**Request for Proposals - Addendum**  
**For**  
**Royal Bermuda Regiment Coast Guard Substation Facility - Building Repairs**  
**103 ST. DAVID'S ROAD, ST. DAVID'S,**  
**ST. GEORGE'S PARISH**

Procurement No: **PN/2024-001-RBR-CG** Addendum

Addendum No: **2**

Addendum Type: **RFP Question Responses and  
Design Clarifications**

Title PROPOSED SITE & LOCATION PLAN	Sheet <b>A1.0</b>
Date 29/07/2024	Revisions:
Scale As Noted

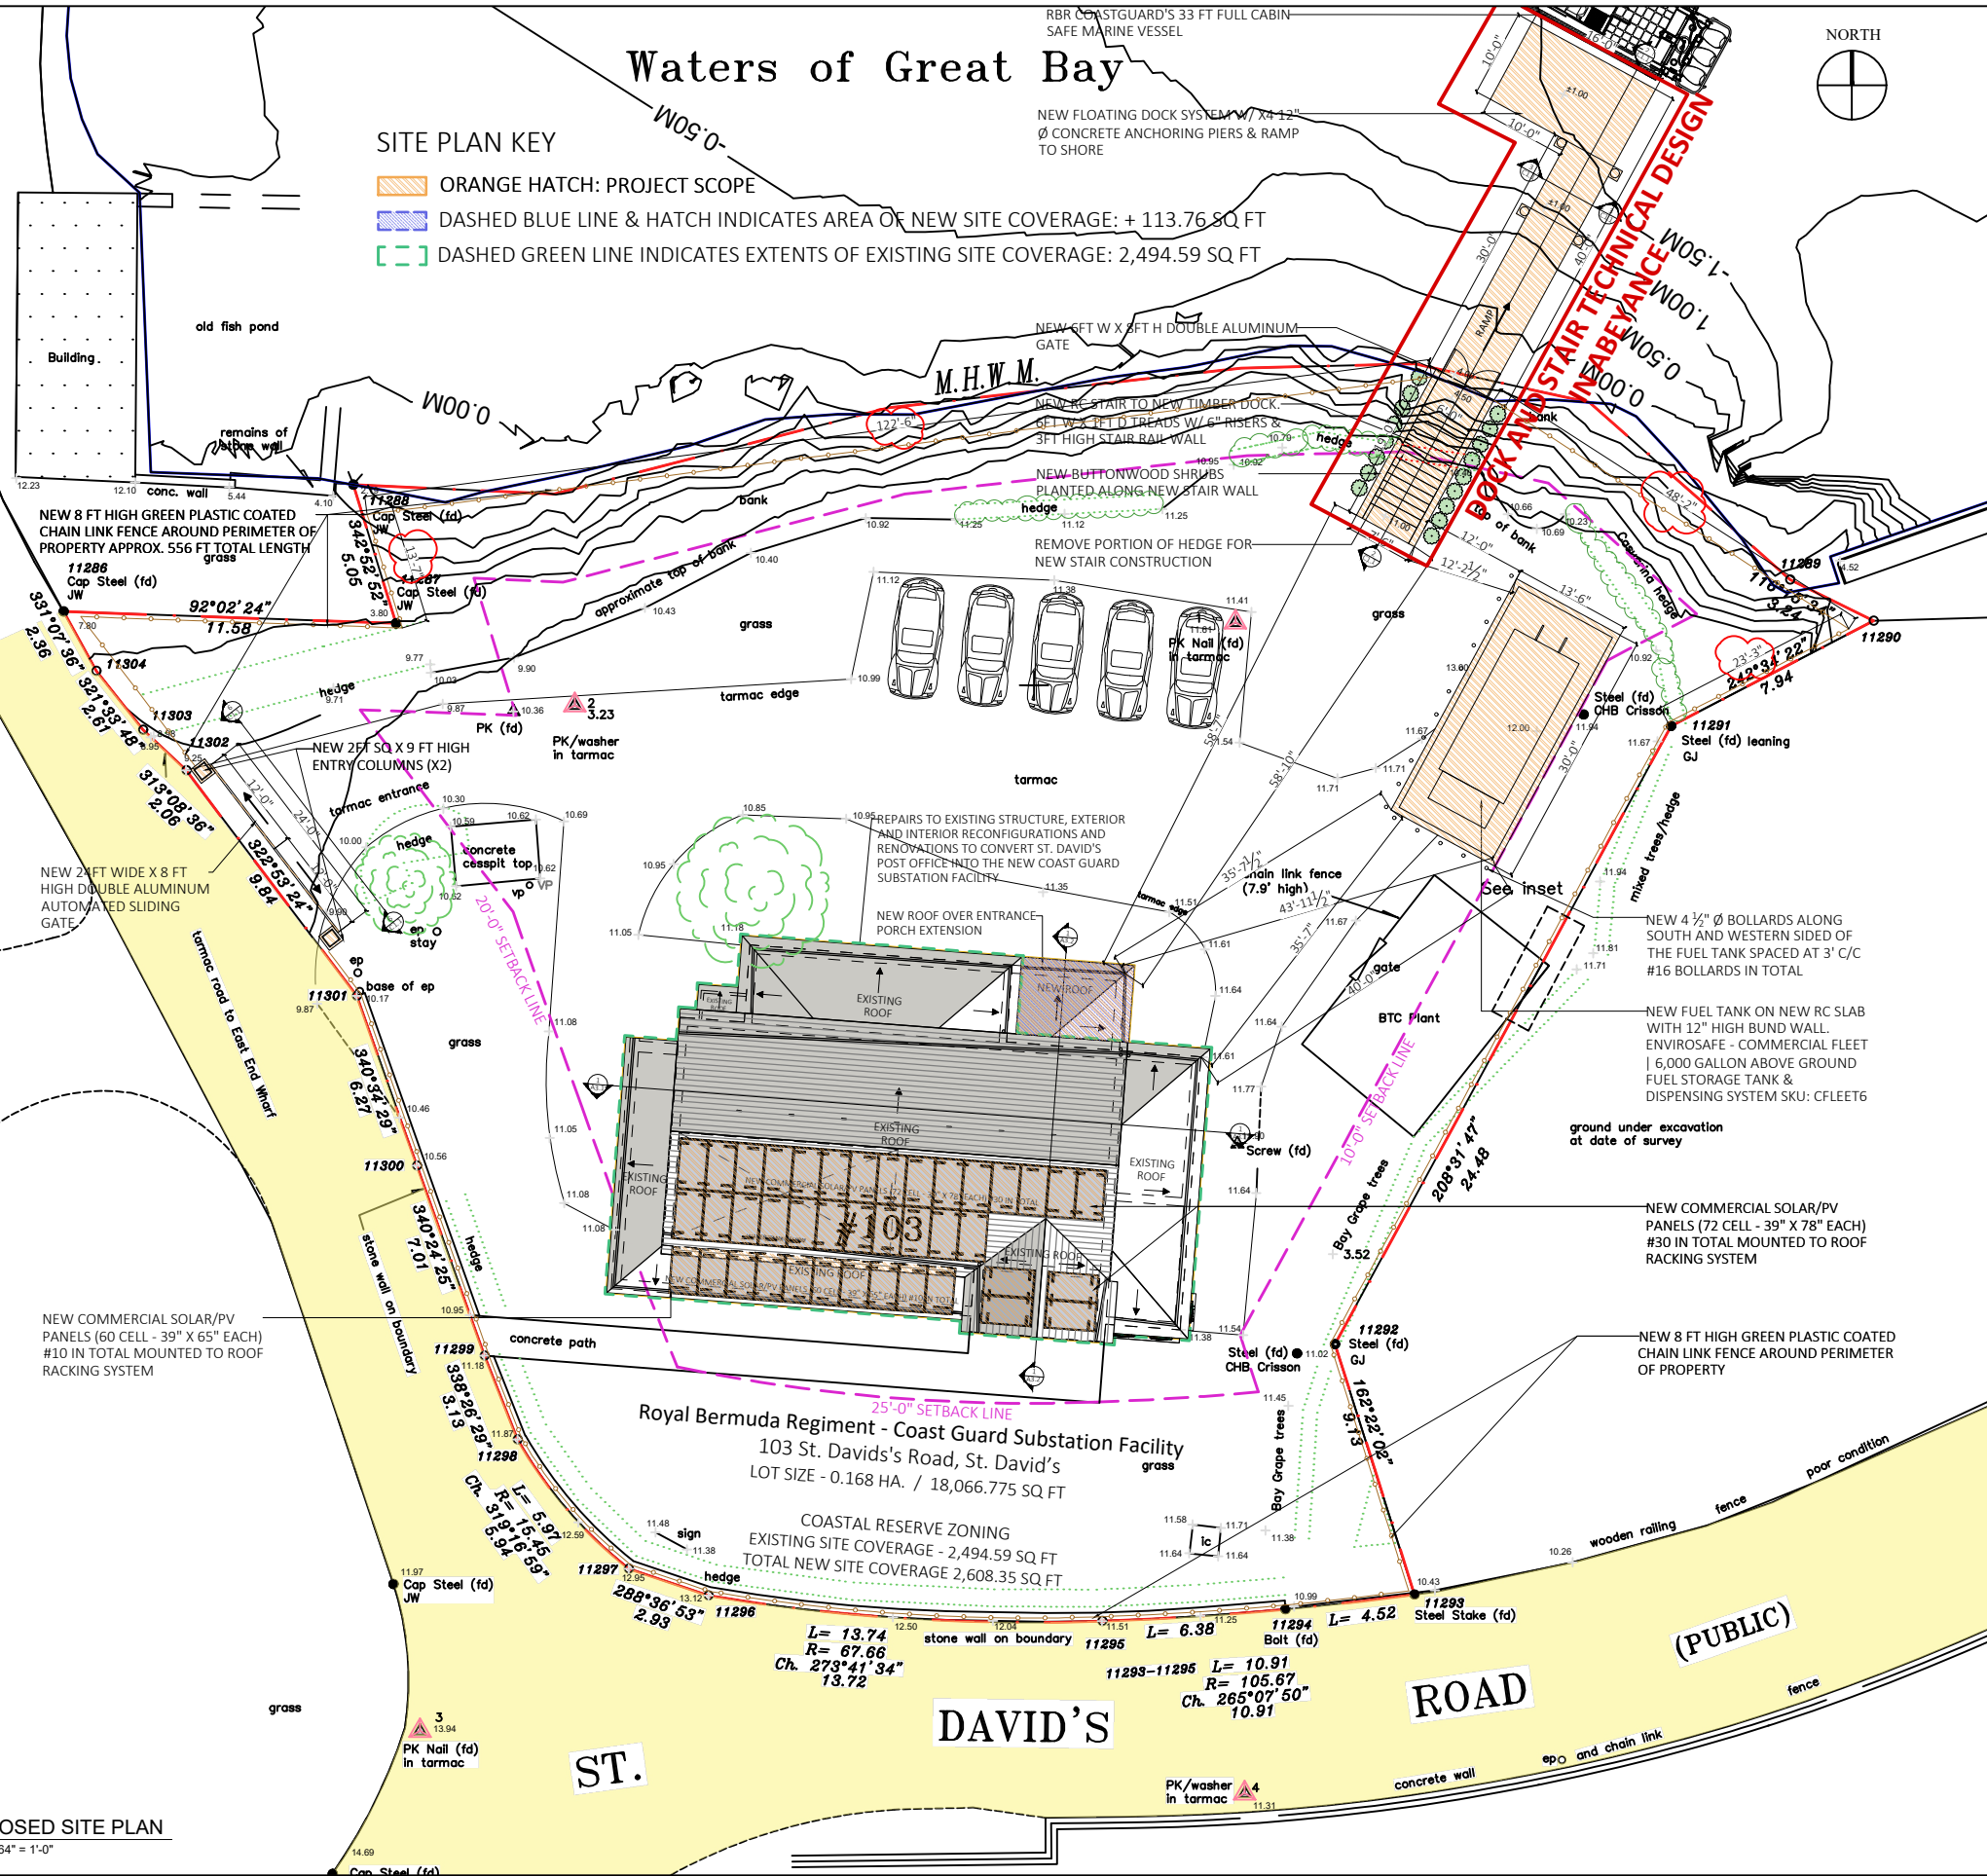
No	Question	Response
1	What items will be owner supplied?	<p>The Bermuda Government will provide the Contractor with the owner supplied specifications and a nominated supplier list (after contract award) as well as a provisional sum (see Addendum 3) for the following owner supplied items:</p> <ul style="list-style-type: none"> <li>- Windows</li> <li>- Doors</li> <li>- Glazing</li> <li>- Appliances/Equipment</li> <li>- Plumbing Fixtures (including drain assembly)</li> <li>- Floor finishes</li> <li>- Wall and wall base finishes</li> <li>- Fire/Security Systems</li> <li>- Front Gate Automation System</li> <li>- Front Entrance Gate</li> <li>- Electrical/Lighting Fixtures</li> </ul> <p>The Contractor will be responsible for procuring these items; the Bermuda Government will prepay the Contractor for these items prior to placing the order.</p>
2	What is the height of the fuel tank bund wall?	See drawing sheet S1.5 "Typical Oil Containment Bund Wall Section". Disregard the 12" height call out on drawing sheet A1.0.

18	Is there a requirement to have barbed wire on the perimeter fencing and entrance gate?	Not in the current scope of work.
19	Please confirm the units of the land survey spot elevations.	On sheet A1.0 'Proposed Site Plan' the land spot elevations are in feet (imperial); ocean contours are in meters (metric). On the topographical land survey (issued by Gov't land surveyors) spot elevations are in metric.
20	The windows to be salvaged appear to have damaged gaskets. Do the gaskets need to be replaced as part of this project scope?	Yes, as per architectural drawing sheet D1.1.
21	When was the land topographical survey carried out?	Original land topographical survey was carried out by the Bermuda Government Survey Department in 2011 and updated in 2022 and 2023 by the Bermuda Government land surveyors to include level labels and seafloor contours respectively.
22	Are any of the survey markers listed in the survey drawings missing?	TBC by contractor during construction. Discrepancies to be brought to the Bermuda Government's attention.
